TECHNICAL BULLETIN
Bell Helicopter **TEXTRON**
A Subsidiary of Textron Inc.

NO 407-99-20

SUBJECT: **FREEWHEEL RETURN LINES,
REPLACEMENT AND RELOCATION OF.**

HELICOPTERS AFFECTED: Bell 407 Serial Numbers 53000 and 53002 through 53285

Figure 3. Transmission Bay Bracket Installation

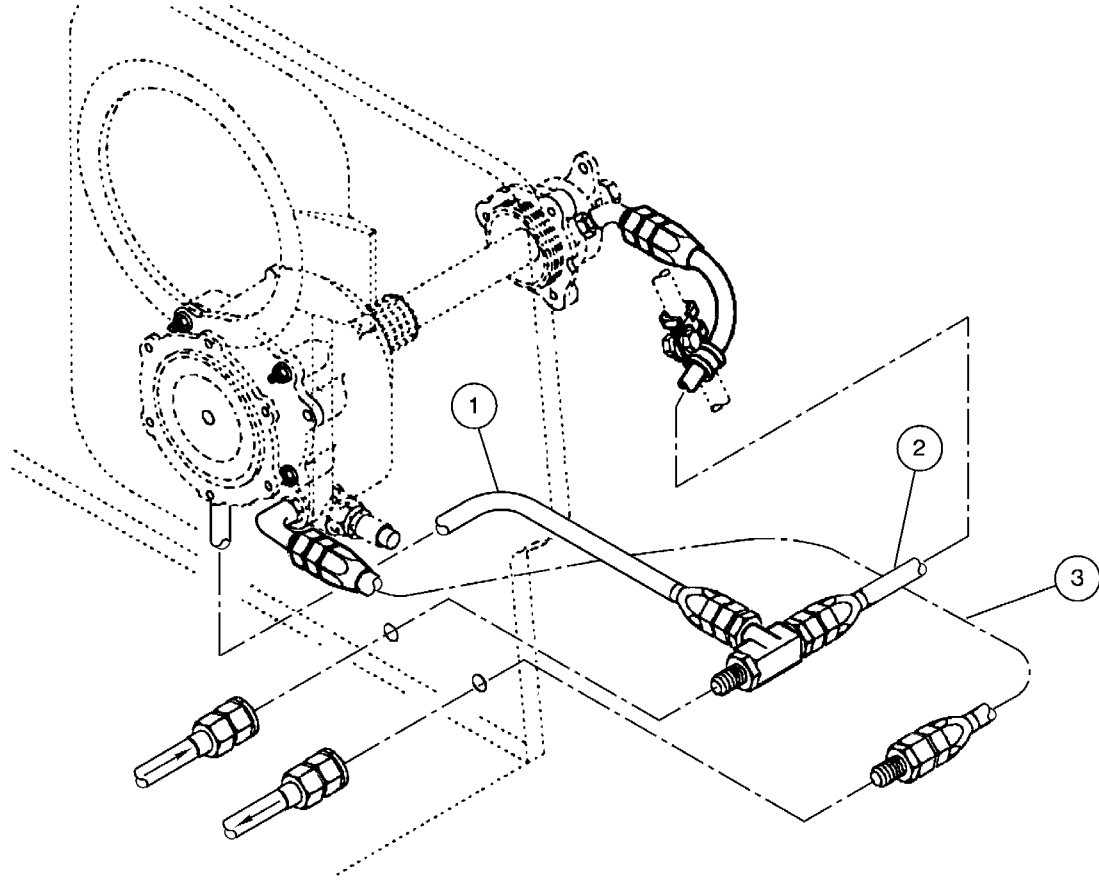
- f) Remove the rivets and discard the bracket (8).
5. Install the new bracket (2), using two rivets (3). Apply a bead of sealant (C-308) (Refer to Figure 3).

Figure 1. Re-route of Engine Bay Oil Return Hose

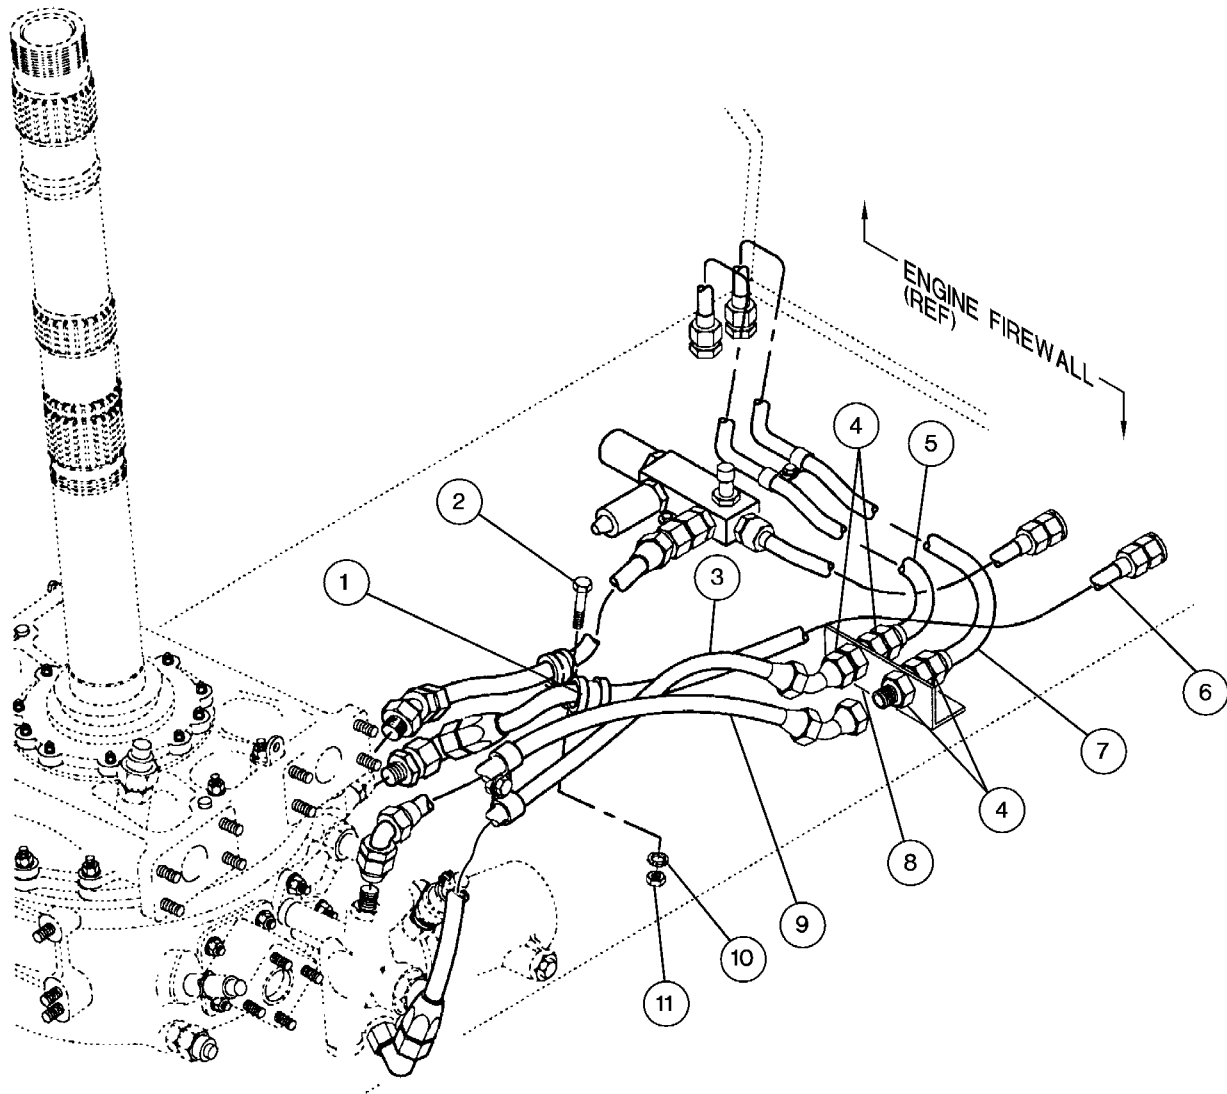
3. In the engine bay, re-route the freewheel oil return hose (3), under the freewheel oil pressure hose, (1) and (2) (Refer to Figure 1).
4. Rework the transmission bay as follows (Refer to Figure 2):

Reroute the freewheel oil return hose (3) under the freewheel oil pressure hoses (1) and (2).

Figure 2. Transmission Bay Rework

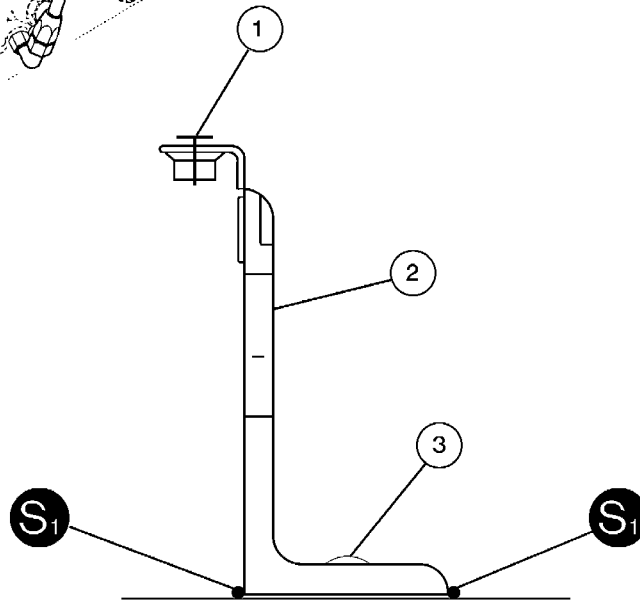
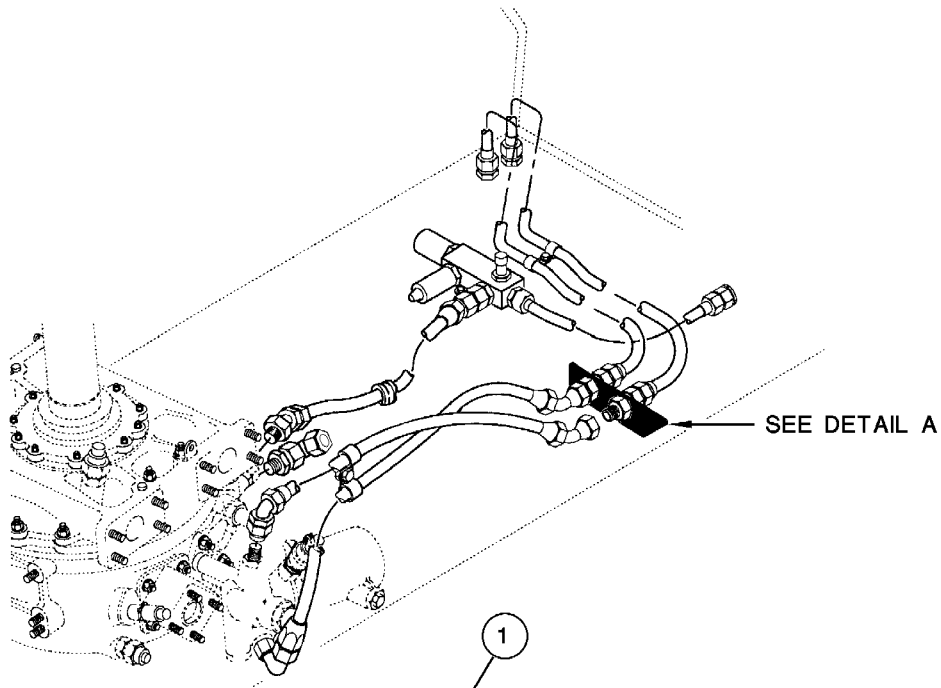
- a) Remove and retain the screw (2), the nut (11), the washer (10) and the clamp (1).
 - b) Remove and discard the oil return hose (6).
 - c) Disconnect the oil hose assemblies (3), (9) and hose assemblies (5) and (7) from the unions (4).

- d) Remove and retain the unions (4) from the bracket (8).
 - e) Remove the necessary interior panels to gain access to the rivet heads in the bracket (8).

Figure 4. Transmission Bay New Oil Hose Installation (Sheet 1)

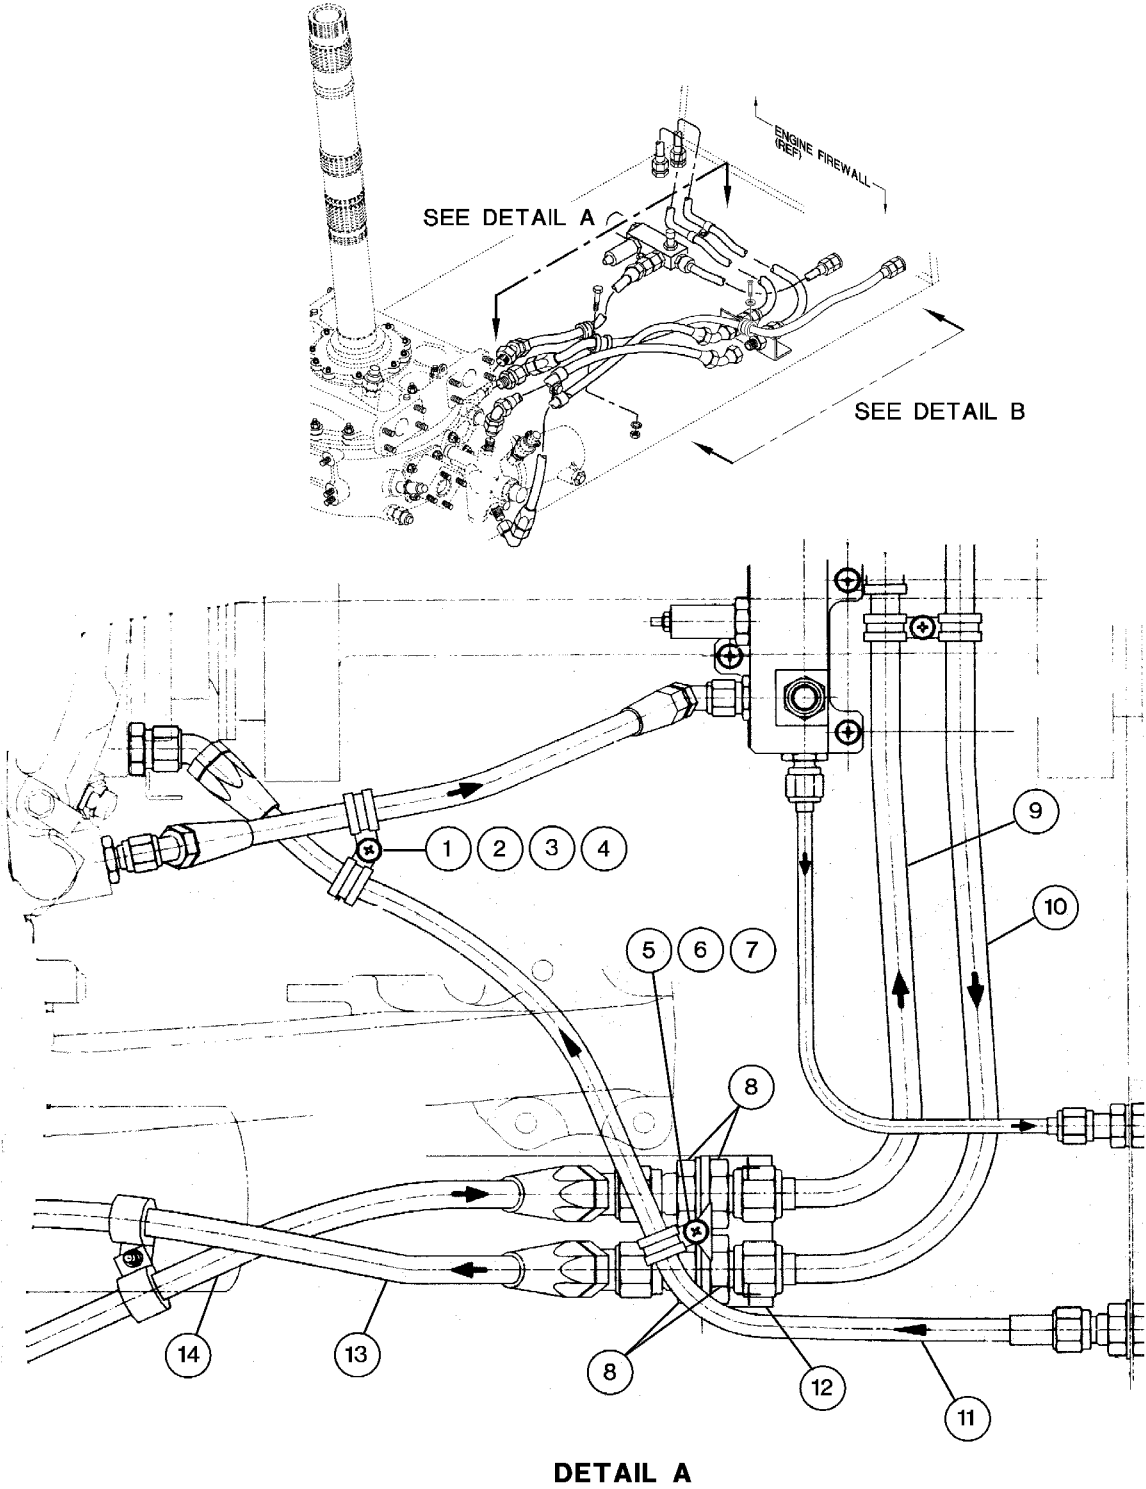
6. Install the removed unions (8) and re-connect the oil hose assemblies (14), (13), (9) and (10) on the bracket (12) (Refer to Figure 4).

7. Install the new oil return hose assembly (11) in the transmission bay as follows (Refer to Figure 4):
 - a) Connect the straight fitting of the hose assembly (11) to the union in the engine firewall and the angled fitting to the union on the transmission.

- b) Install the clamp (7) on the oil return hose assembly (11) fasten to the bracket (12) using a screw (5) and a washer (6).
 - c) Relocate the existing clamp (2) and attach with the screw (1), the washer (3) and the nut (4).
